Value Engineering
Final Report

San Acacia Fish Passage

March 15, 2007

UNITED STATES DEPARTMENT OF THE INTERIOR BUREAU OF RECLAMATION MIDDLE RIO GRANDE PROJECT – NEW MEXICO SAN ACACIA REACH SAN ACACIA DIVERSION DAM NATURALIZE CHANNEL PASSAGEWAY PLAN VIEW	
CADD SYSTEM CADSYS ALBUQUERQUE, NEW MEXICO	CADD FILENAME FTLNAM MARCH, 2007
SHEET 1 OF 2	PROPOSAL 1

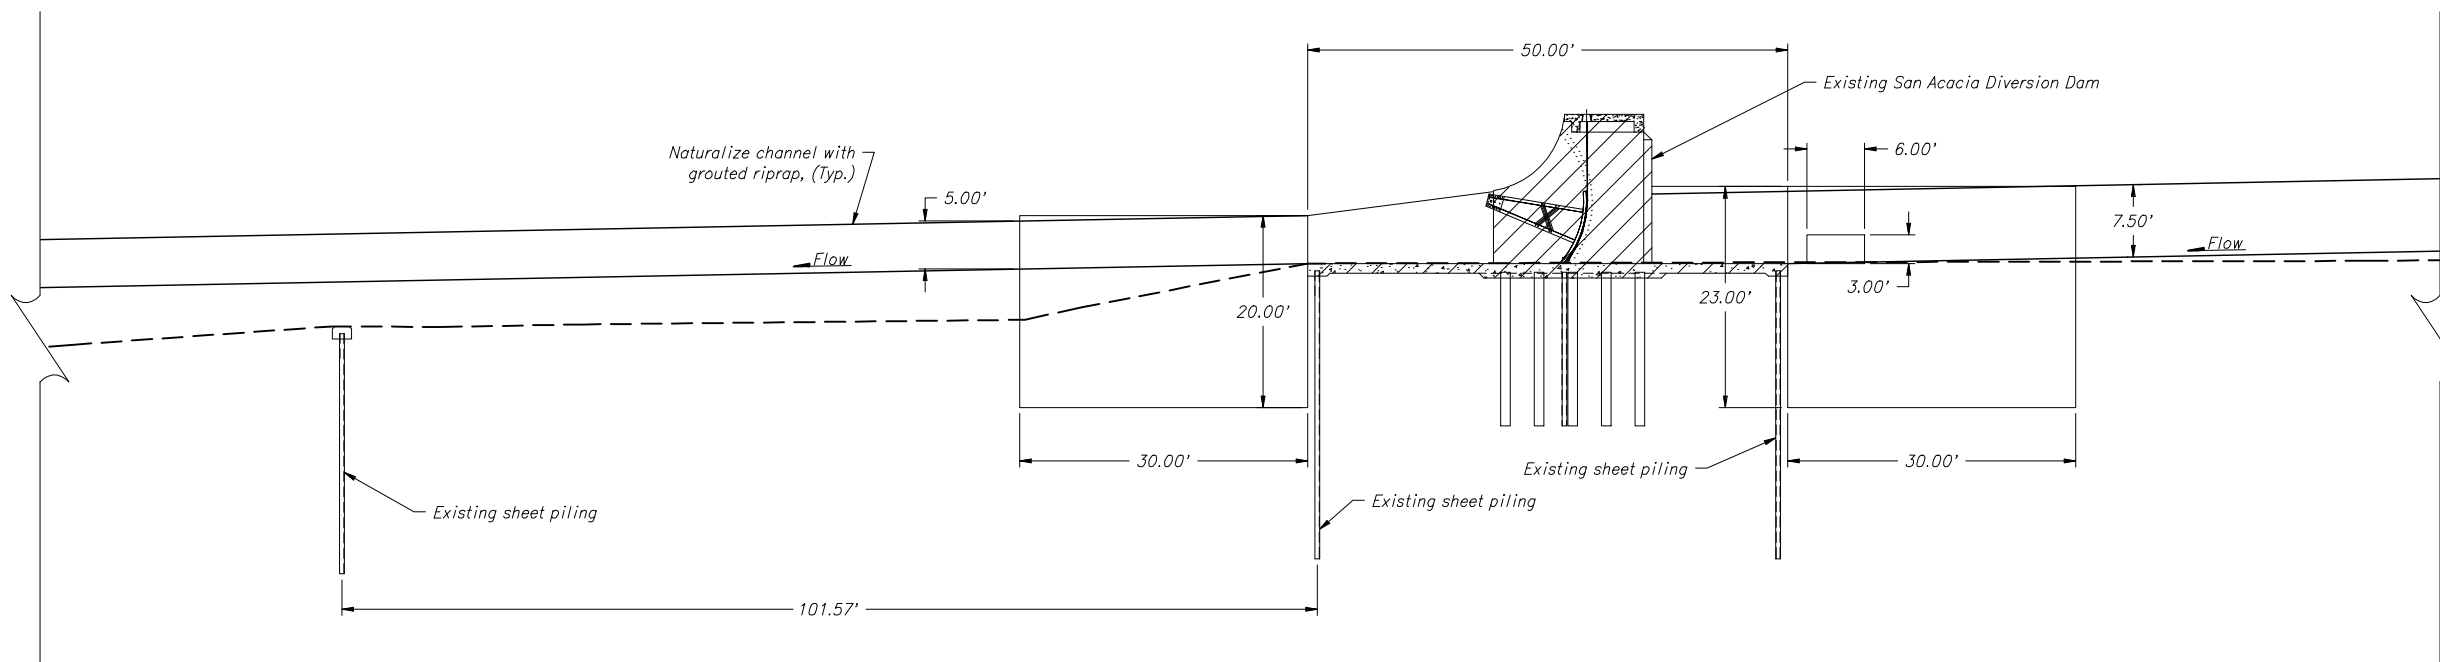
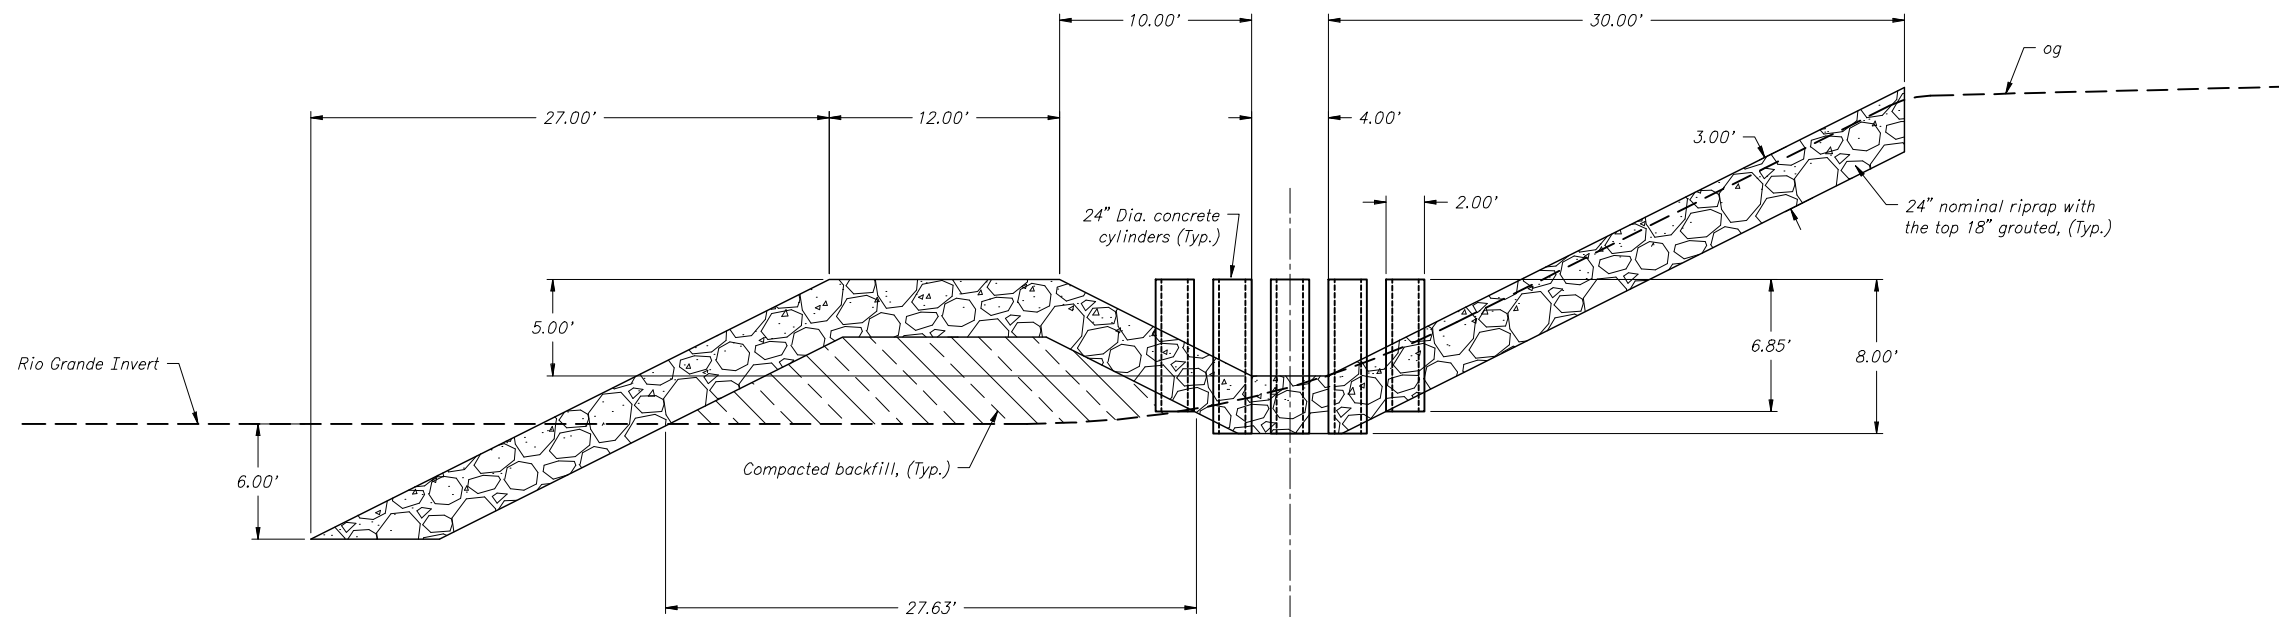
Proposal: Install a naturalized channel through the eastern most bay in San Acacia Diversion Dam.

Proposal Description: Fish bypass at San Acacia Diversion Dam could be achieved by constructing a naturalized channel. The bed would consist of grouted riprap. To reduce flow velocity and provide diversity in the flow pattern, reinforced concrete pipe baffles would be installed, protruding vertically from the channel bed. This channel would pass through the eastern most bay of the dam. Geometric characteristics are as follows:

- trapezoidal channel with 2:1 (H:V) side slopes
- channel gradient at 1.0 percent (slope = -0.01)
- bottom channel width of 4 feet
- pipe baffle diameter of 2 feet
- pipe baffle length of 6.85 to 8.0 feet, extending approximately 5 feet above the channel invert
- longitudinal distance between pipe baffles of 10 feet
- transverse spacing between pipe baffles of approximately 1 foot; five pipes would be installed at each cross-section
- average water depth in the fish bypass channel between 3 and 4 feet
- maximum water surface head (H) of 17 feet (checked water surface behind dam)

The fish passage channel would be separated from the main Rio Grande channel by a berm with a crest height 5 feet above the fish passage channel invert. The berm would have a top width of 12 feet and 2:1 (H:V) side slopes. The berm and fish passage channel would be covered with 3-foot-thick grouted riprap, extending from 6 feet below the Rio Grande channel invert (on the river side) to the top of the historical bankline on the east side of the river.

The approximate fish passage channel length is 800 feet upstream and 800 feet downstream of the diversion dam. It will run along the eastern edge of the current Rio Grande channel, passing through the easternmost bay of San Acacia Dam. Optionally, the distance downstream of the dam could be shortened by removing the dam sill where the channel passes through San Acacia Diversion Dam.

The design for the entrance (Bernal Entrance) at the downstream end of the fish bypass channel is a single row of sheet pile starting at the entranceway to the fish bypass channel that is driven on a 30 degree arching pathway to the right river embankment. The sheet pile row would have notches of various heights to allow for different flow conditions in the river. At the entrance to the fish bypass channel is a series of large boulders (4-foot by 5-foot) which would be placed between the sheet pile and the left river embankment to create a tranquil flow condition between the fish bypass channel entrance and the river. The sheet pile would also direct the RGSM to the approximate location of the entrance for the fish bypass channel.

UNITED STATES DEPARTMENT OF THE INTERIOR BUREAU OF RECLAMATION MIDDLE RIO GRANDE PROJECT - NEW MEXICO SAN ACACIA REACH SAN ACACIA DIVERSION DAM PIPE AND VALVE SYSTEM PLAN VIEW AND TYPICAL PROFILE	
CADD SYSTEM CADSYS ALBUQUERQUE, NEW MEXICO	CADD FILENAME F11NAM MARCH, 2007
PROPOSAL 2

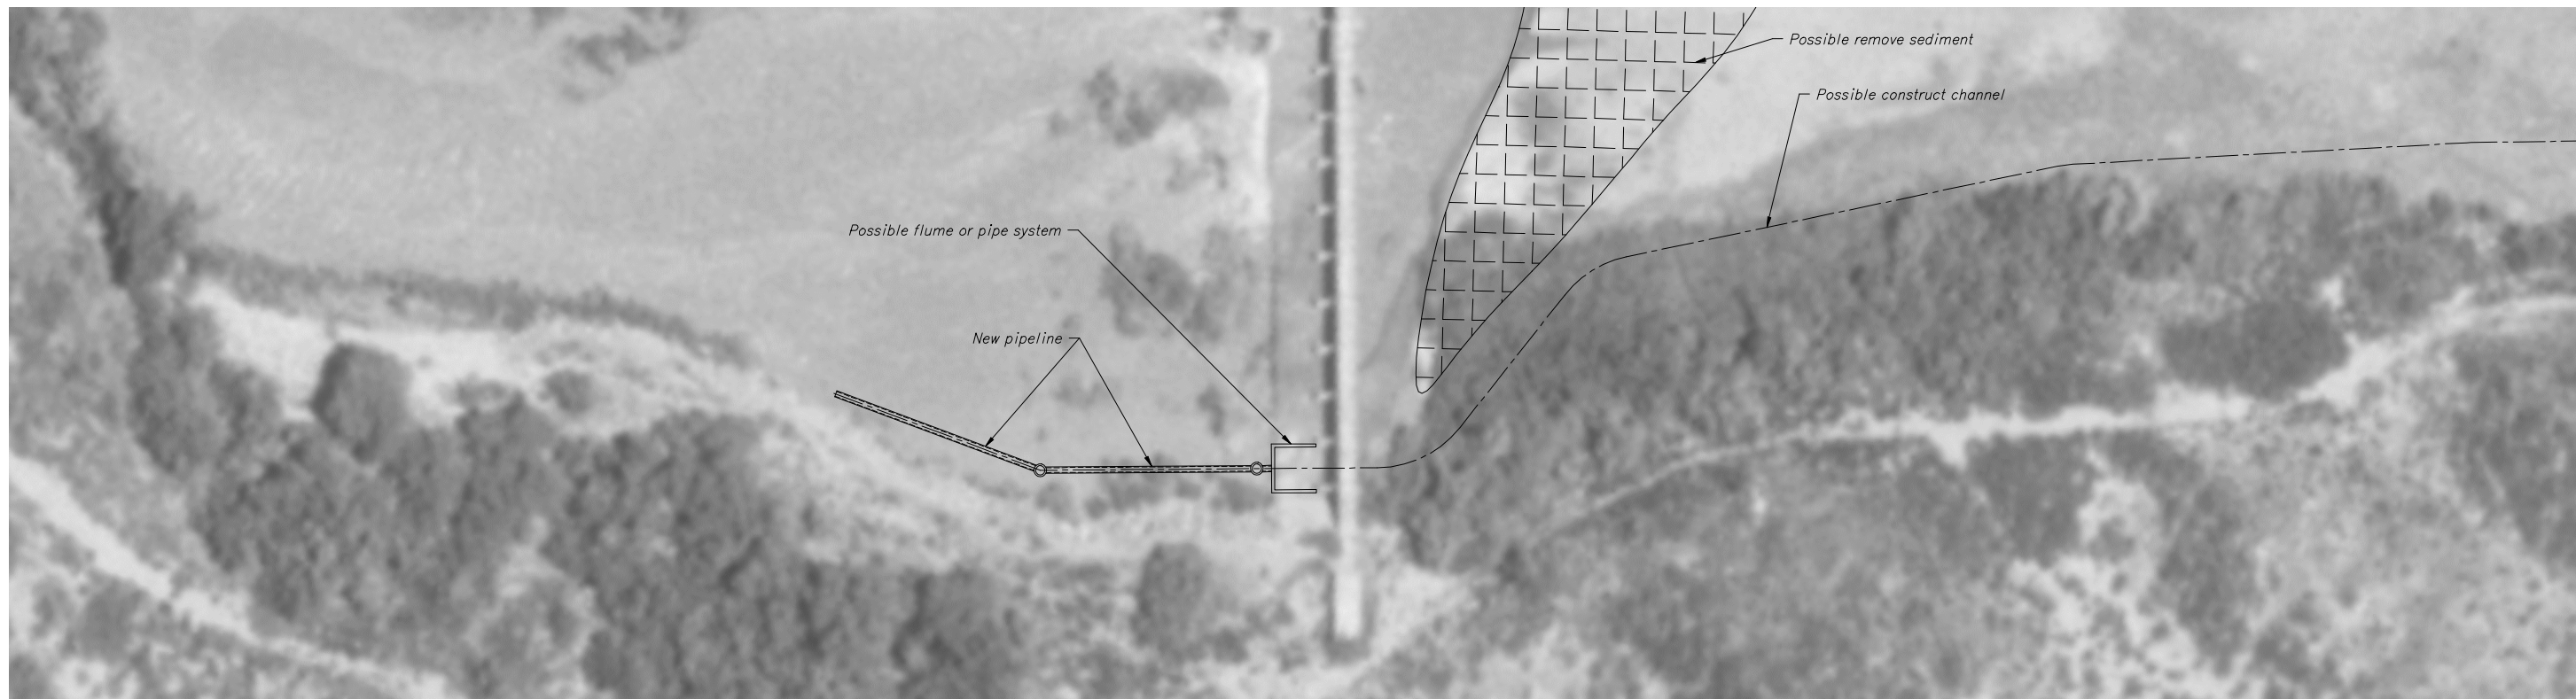
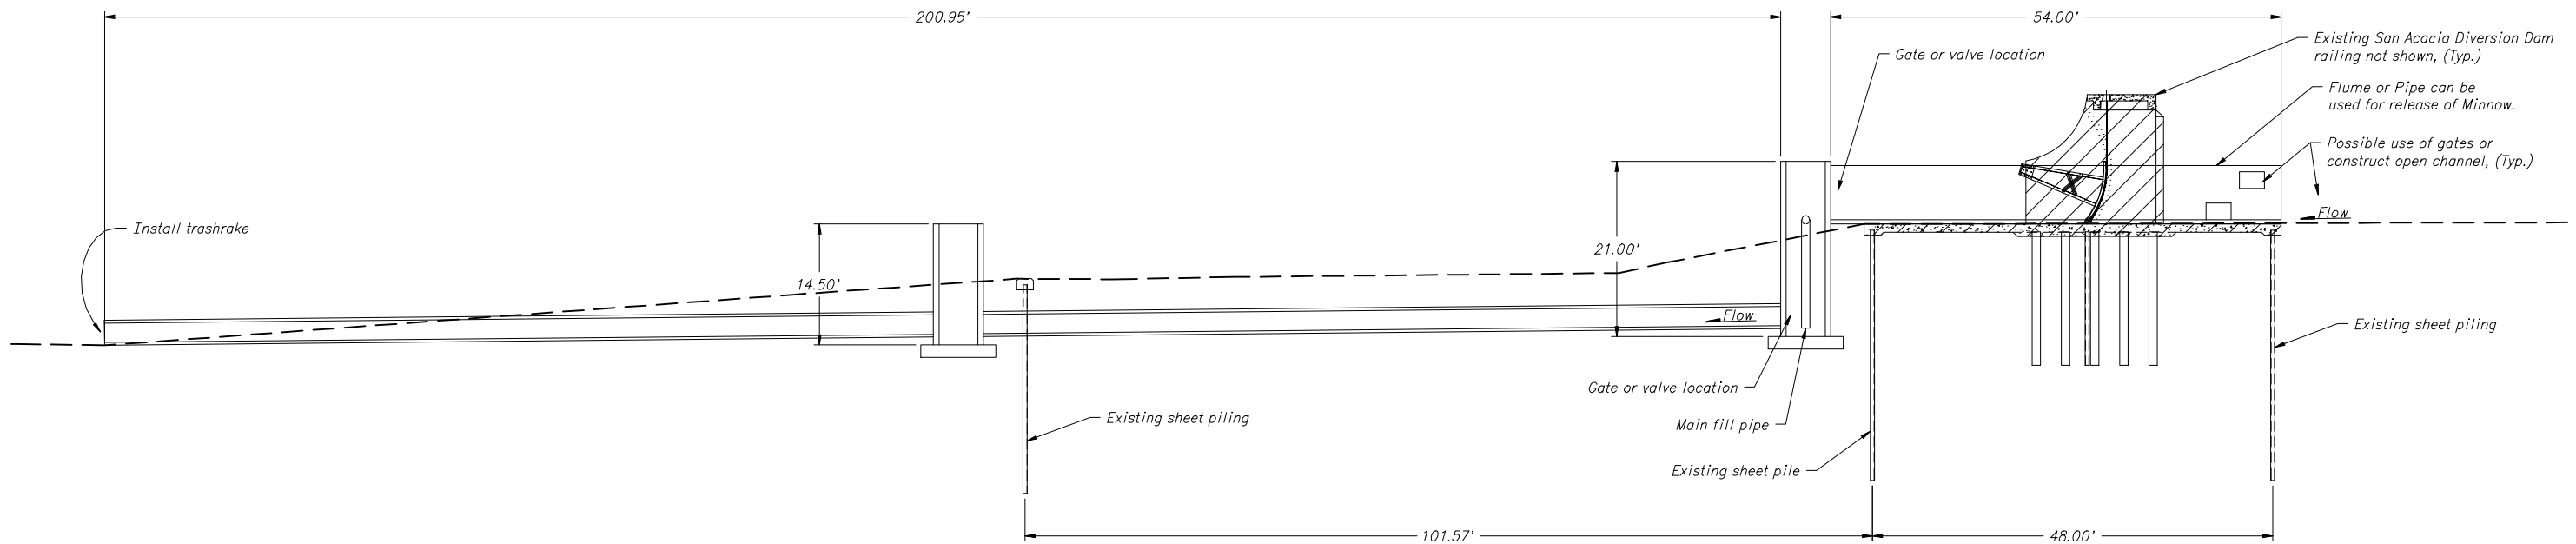
Proposal. Install a pipe and valve fish passage system. The system attracts Rio Grande RGSM into a vertical pipe (stack) that is periodically filled with water that in turn lifts the fish to the release levels at the checked and unchecked Rio Grande behind the dam.

Proposal Description: The concept uses a 5-foot diameter horizontal pipe that is below the dam and provides the attraction water in the river below the dam. This pipe would extend into the tailwater below the dam for over 100 feet. The flowing water in the pipe guides the fish up the pipe to a vertical lift stack that fills with water. A general flow in the pipe should be between 1 and 1.2 feet per second. Prior to filling the vertical pipe stack, the horizontal pipe is closed at the stack base, trapping fish that ascended the horizontal pipe and entered at the bottom of the stack. At this time the vertical pipe is filled with water, lifting the trapped fish. At the fish exit level there will be an inflow of water to further guide fish out of the vertical pipe and out into the Rio Grande upstream of the dam. There would be two different fish exit elevations on the vertical stack to accommodate fish passage at checked and unchecked operations, or an alternate open flume that will accommodate several exit elevations.

Some additional features of this concept include a gravity water filling control for the vertical stack. This needs to be a gradual process so fish can orient to the filling column (maybe stay near the surface). In addition this filling should be with “non-entrained air” water and should be filled from the stack bottom. Free dropping water into the stack could scare fish and keep them near the bottom and not near the top where the discharge guide flows would be detected.

A controlled, screened “leakage” near the base of the vertical stack into the horizontal attraction pipe will provide continued attraction flow. Inflow of water at the fish exit will maintain a flow that RGSMs will orient to and continue swimming upstream and out the exit.

A large mesh trash rack at the fish exit would reduce debris in the plumbing from upstream and a narrow trash rack grate at the fish entrance should reduce predator (fish, avian, and mammal) access to the pipe.
